CITY OF PORTLAND, MAINE
Department of Building Inspection

REASON FOR PERMIT: To Construct a single Family Dwelling

SITE PLAN REVIEW

RE: Sunset Ave., Great Diamond Island
83A-K-5-10

Weber's Site Plan 10/92

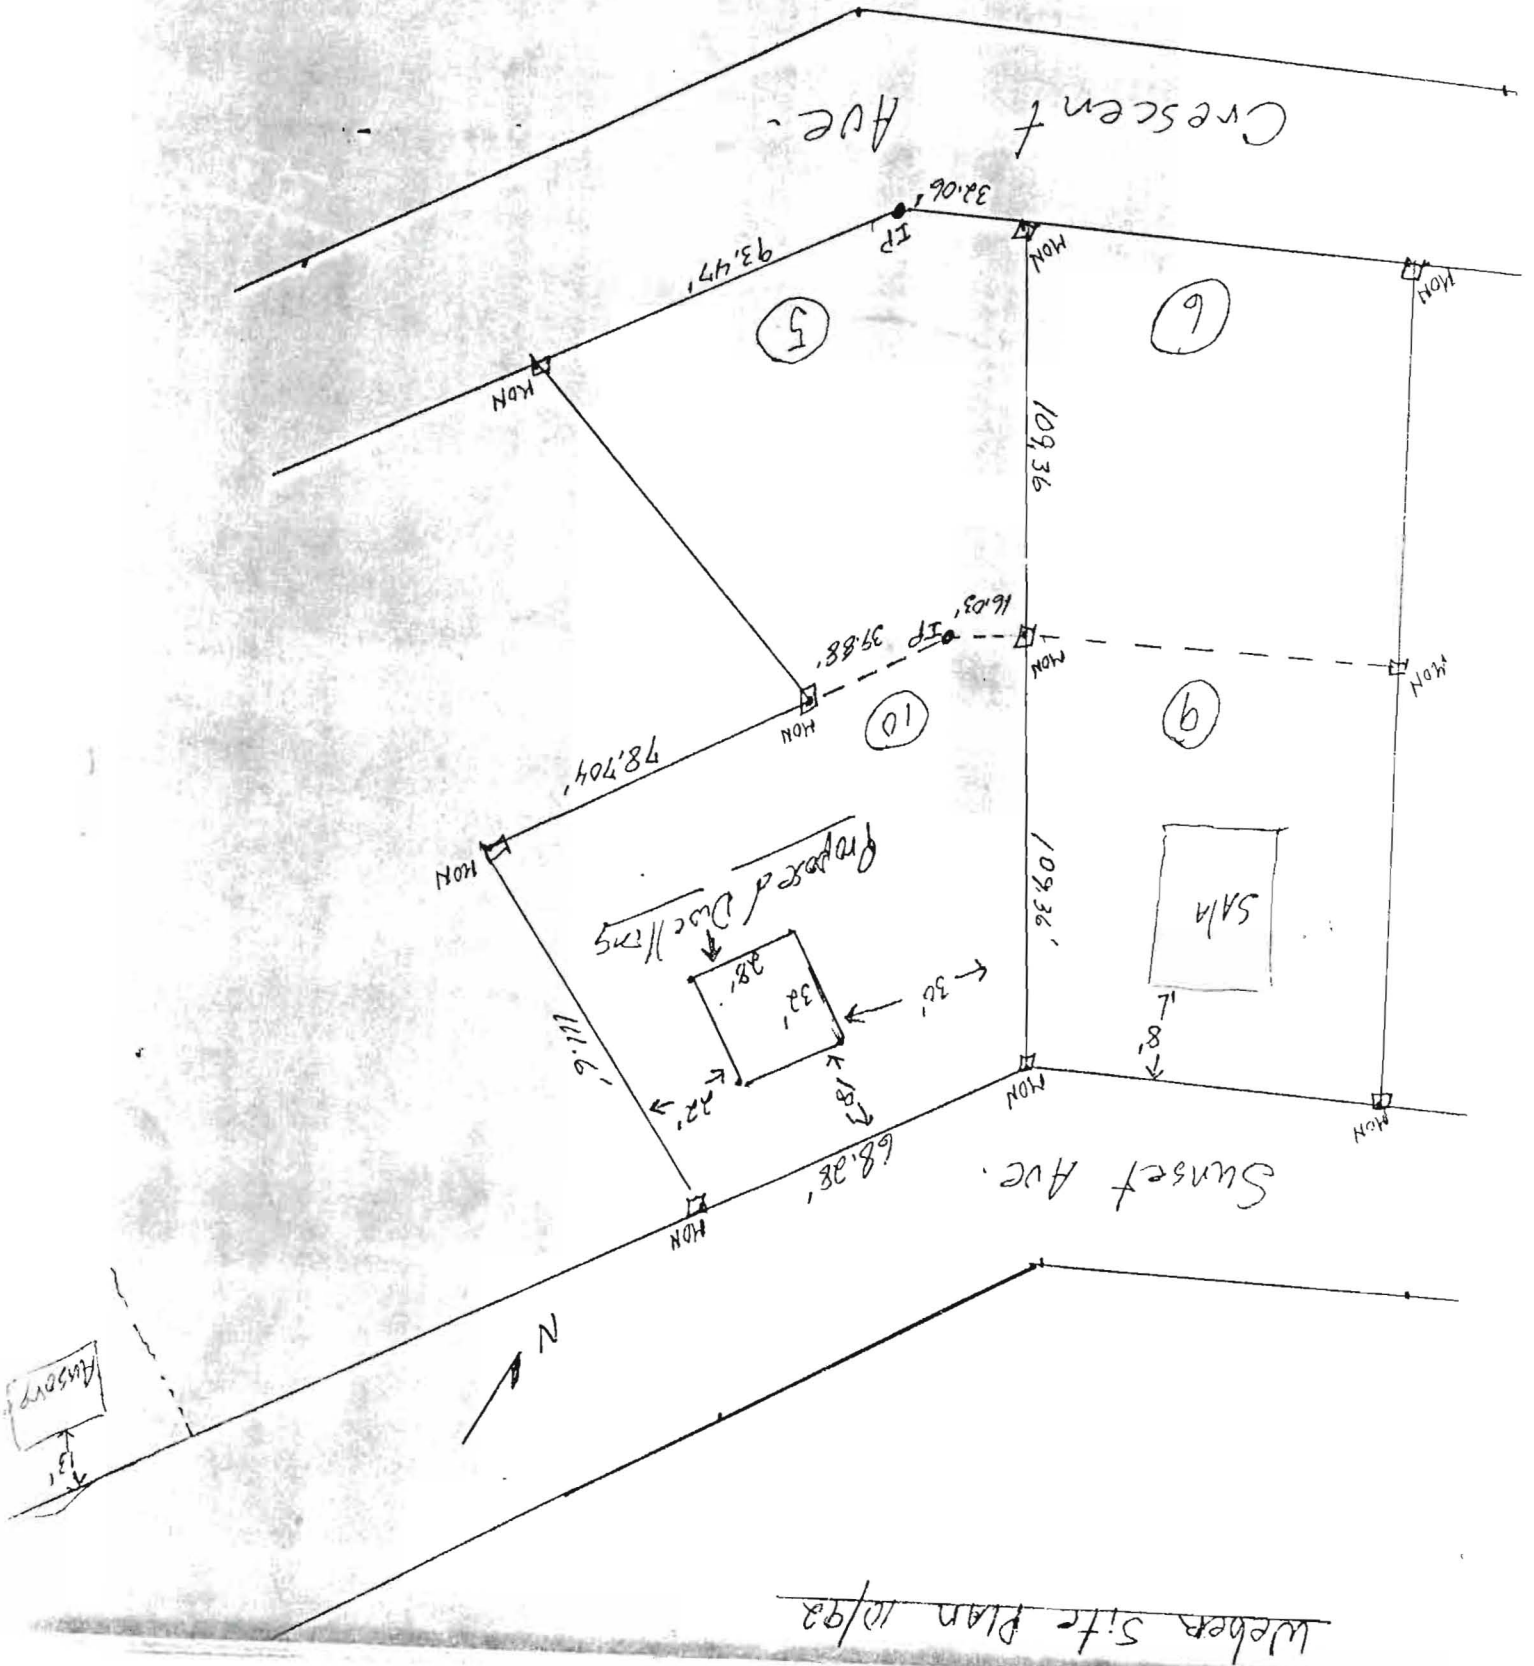
CHECK LIST AGAINST ZONING ORDINANCE

Rear Yards - 25'

Side Yards - 22' and 30'

Front Yards - 18'

Lot Area - 21,643 sq ft

Building Area - 28 x 32' = 896 sq ft

Width of Lot - 86'
